## AGENDA FOR THE PLANNING COMMITTEE

<b>PLANNING COMMITTEE</b>		<b>AGENDA ITEM NO:</b>	<b>B1</b>
<b>Date:</b>	20 <sup>th</sup> February 2024	<b>NON-EXEMPT</b>

Application number	P2024/0027/NMA
Application type	Non-Material Amendment
Ward	Tufnell Park
Listed building	none
Conservation area	Within 50m of Tufnell Park Conservation Area Within 50m of Hillmarton Conservation area
Development Plan Context	Designated Brownfield Site Holloway Prison Site (HPS) SPD Emerging Site Allocation NH7 (November 2018). Local view corridor from Archway Road (LV4) Local view form Archway Bridge (LV5). Not in a location identified as suitable for tall buildings LL4 Local Landmark Camden Road New Church tower and Spire Within 100m of Strategic Road Network and Transport for London Road Network Major cycle route
Licensing Implications	None
Site Address	Former Holloway Prison, Parkhurst Road, London, N7 0NU
Proposal	Non-material amendments to planning permission ref: P2021/3273/FUL dated 05/08/2022. The amendments proposed include the installation of a second staircase into Block C1 and C2 for the purposes of fire safety with associated internal layout changes resulting in modifications to the dwelling

Figure 4: Block C1 staircase changes (proposed amended on right hand side)

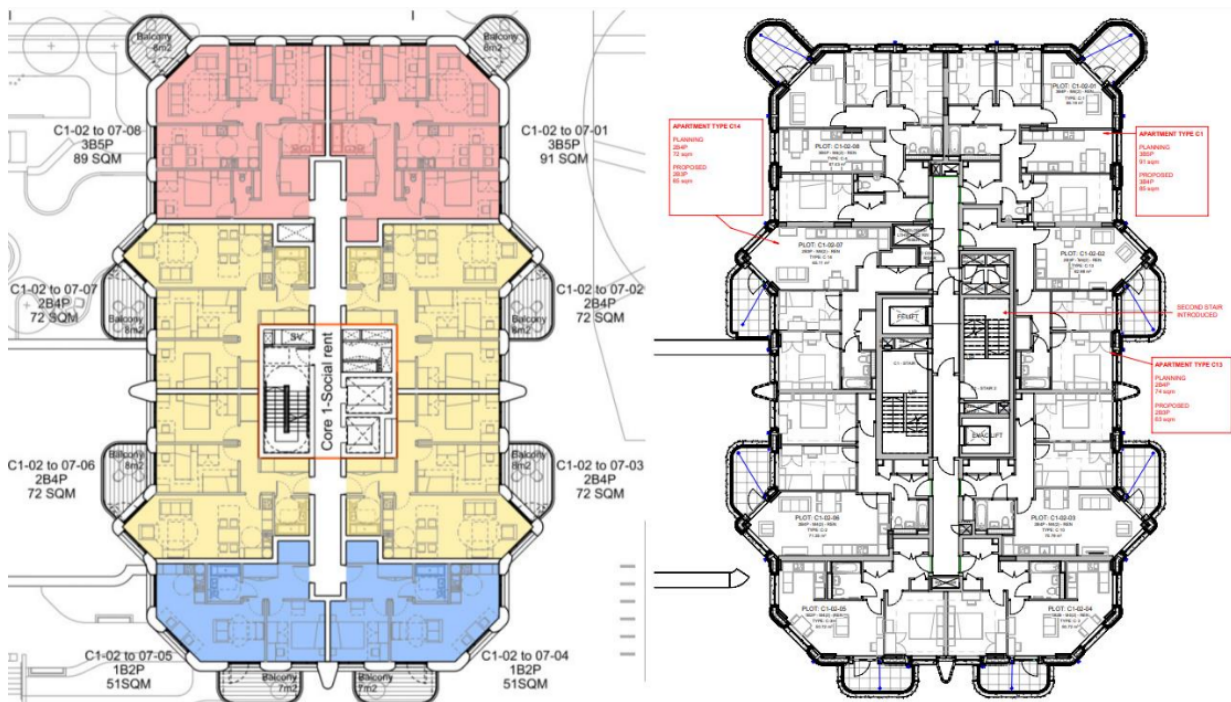
- 11.8 The introduction of a second staircase into blocks C1 and C2 result in a reduction of around 35 – 40sq.m of functional residential floorspace per floor which is now dedicated to circulation and access. There is no fundamental change to the layout. The originally designed staircase and lift core was located centrally around a central linear corridor in each block with a lift to one side of the corridor and a staircase to the other side. The change to the scheme results in the stair and lift core being elongated on each side of the central corridor to provide a staircase on both sides accessible from each floor with the exception of the basement in block C1.

Figure 6: Proposed basement to block C

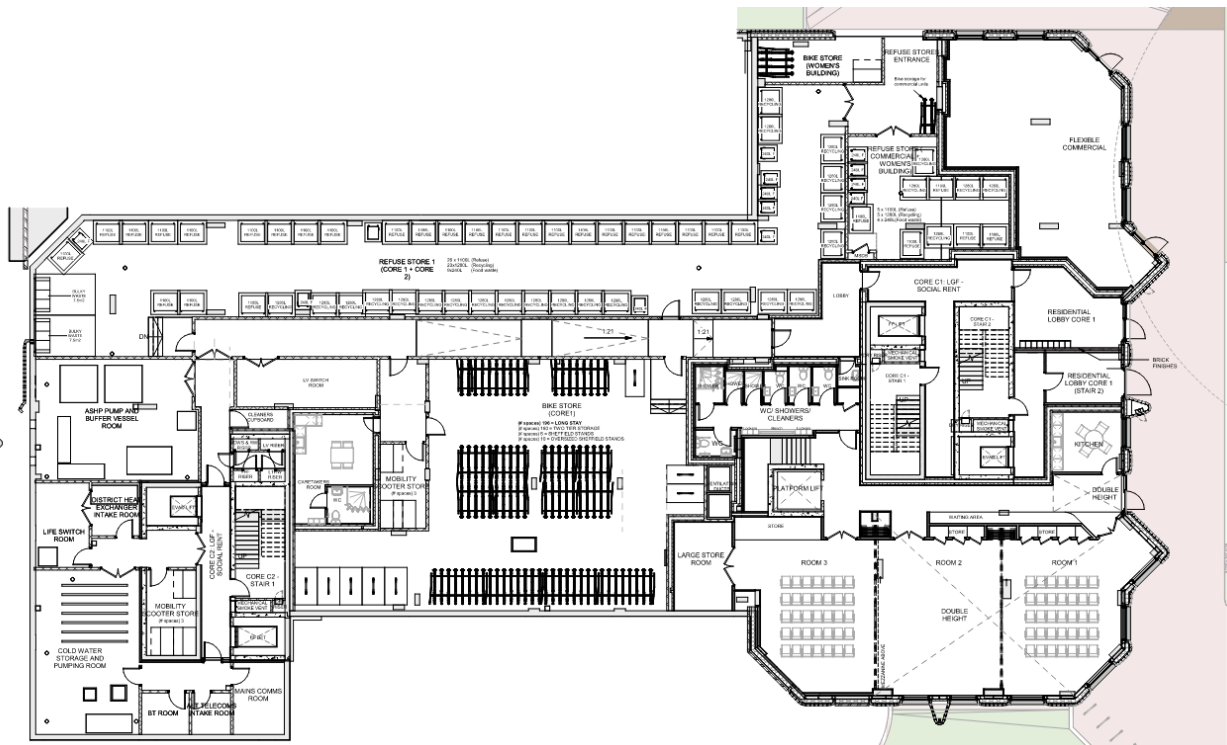
- 6.4 At lower and upper ground floor level, the proposed staircase amendments impact upon the layout and siting of building management facilities such as plant, utilities, cycle parking, toilets and showers and generally involves the re-siting of partitions rather than the removal of such facilities. With respect to the Women's Building, the proposed amendment maintains a double floor height dividable multipurpose hall along with meeting rooms, toilets and refuse storage. The larger staircase core absorbs some of the space and therefore at the lower ground floor, Page 15

encompasses some of the area previously dedicated to general needs bike storage, however, the number of spaces indicated for the basement is proposed to increase despite a smaller storage area. A flexible commercial space at lower ground floor level is also proposed to decrease minimally. At the ground floor level, the number of cycle parking spaces is reduced from 122 to 52. However, the fundamental layout of the Women's Building remains the same with the same functions and divisions across the floor plan.

Figure 7: Proposed upper ground floor to plot C

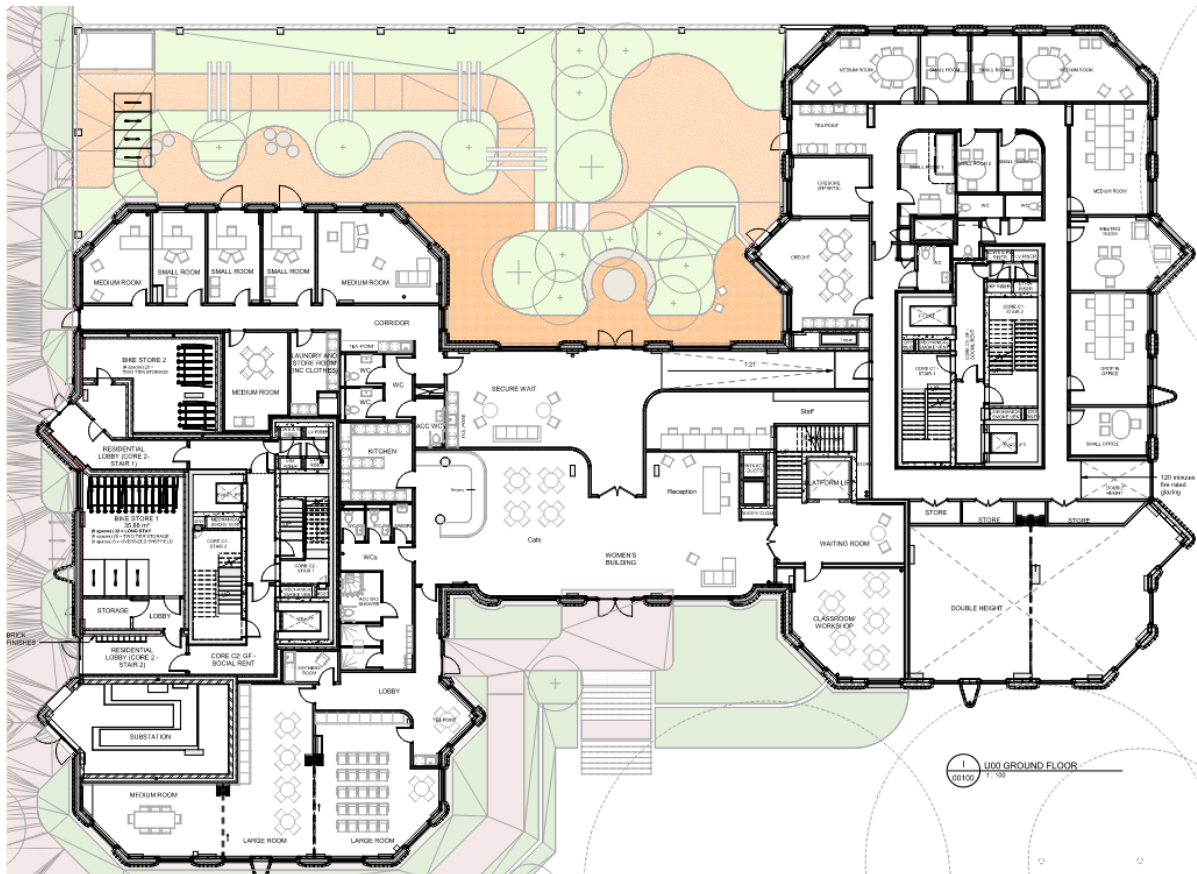
11.12 Within Block C2, the consented plans indicated the presence on ground floor of a commercial unit. This has a consented NIA of 152sq.m or 168sq.m GIA. Due to the necessity of relocating part of the refuse storage and maintain the residential access lobby, the commercial unit is reduced in size to 92sq.m NIA (93sq.m GIA). This would be consistent with one of the other consented commercial units proposed to be located in block B. During the course of evaluating the application at the end of 2021, officers expressed concern (borne out by conclusions in the Committee Report) that given the site's location outside of a defined town centre or other retail location, there would need to be an impact assessment to limit the harm that isolated retail here would have on the function of the existing retail areas. It is considered that a further reduction in commercial floorspace in this location would not harm the qualities or benefits that this scheme would generate. Furthermore, the provision of commercial floorspace was not seen as a critical aspect of the planning balance in favour of this scheme.
